# Access Compliance Report

## Public Rights-of-Way

| Intersection ID: 50616                  | Main Street: PADDLE_OAK_RD | Cross Street: FAWN_LILY                 | Location: SE           |
| ADA ID: 70D6D9B2C8AC                    | Ramp Type: Perp            | Initial Pass/Fail: Fail                 | Overall Compliance: No |

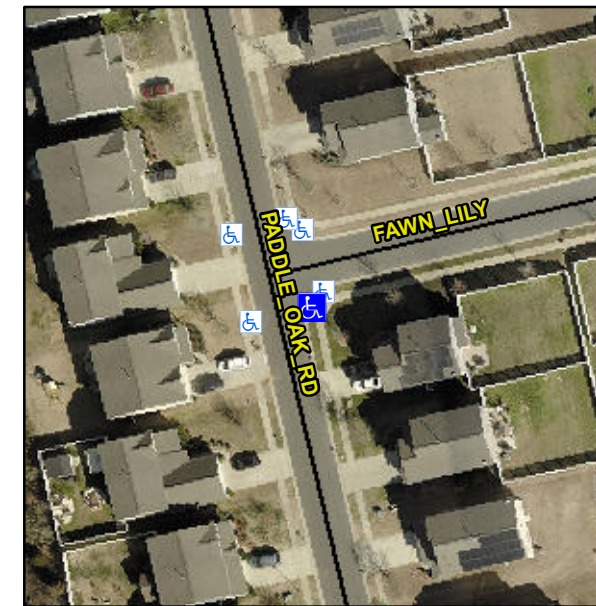
**R304.5.3**

| Compliance | Description           | Data | Compliance | Description                 | Data |
|------------|-----------------------|------|------------|-----------------------------|------|
| Yes        | Ramp Width (in)       | 48.0 | No         | Ramp XSlope (%)             | 6.6  |

**Remove & Replace Entire Ramp.**
